# Access Compliance Report

## Public Rights-of-Way

### (Curb Ramps)

Intersection ID: 10015694	Main Street: IKEA_BV	Cross Street: N/A	Location: NW
ADA ID: 7C1488493D17	Ramp Type: Perp	Initial Pass/Fail: Fail	Overall Compliance: No
Severity Score: 21.25			
Codes/Mitigation Info/Possible Solution		Field Measurements/Component Compliance

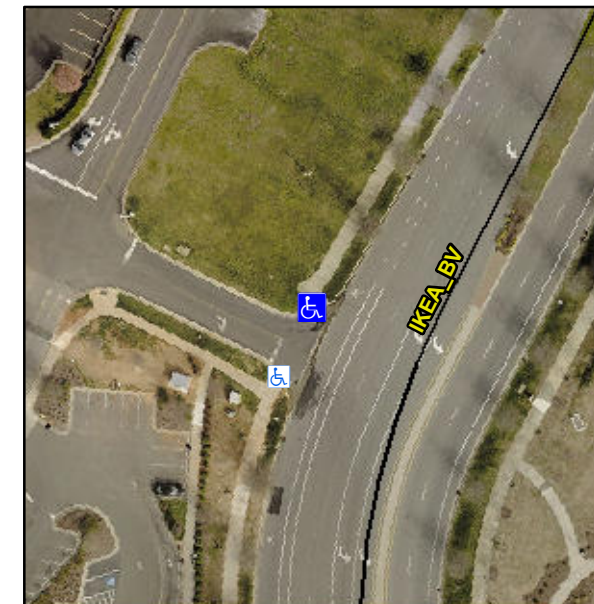
**R304.5.1, R304.2.2**

Compliance	Description	Data	Compliance	Description	Data
N/A	Ramp Length (in)	97.0	No	Ramp Slope (%)	9.6
No	Ramp Width (in)	44.0	Yes	Ramp XSlope (%)	1.8
N/A	Flare Type LT	N/A	N/A	Flare Type RT	N/A
N/A	Flare Slope LT (%)	N/A	N/A	Flare Slope RT (%)	N/A
N/A	Flare Traversable LT?	N/A	N/A	Flare Traversable RT?	N/A
N/A	Landing Length (in)	N/A	N/A	DWS Provided?	N/A
N/A	Landing Width (in)	N/A	N/A	DWS Contrast?	N/A
N/A	Landing Slope (%)	N/A	N/A	DWS Length (in)	N/A
N/A	Landing X Slope (%)	N/A	N/A	DWS Full Width?	N/A
N/A	Landing Curb? (Y/N)	N/A	N/A	DWS Offset (in)	N/A
N/A	Shared Landing?	N/A			
N/A	Gutter Ponding?	N/A	N/A	Gutter Slope (%)	N/A
N/A	Gutter Lip Ht (in)	N/A	N/A	Gutter X Slope (%)	N/A
N/A	Painted X Walk1?	No	N/A	Painted X Walk2?	N/A
	X Walk 1 Direction	To S		X Walk 2 Direction	N/A
N/A	X Walk 1 Width (in)	N/A	N/A	X Walk 2 Width (in)	N/A
	X Walk 1 Slope (%)	3.3		X Walk 2 Slope (%)	N/A
	X Walk 1 X Slope (%)	0.6		X Walk 2 X Slope (%)	N/A

**Remove & Replace Entire Ramp.**
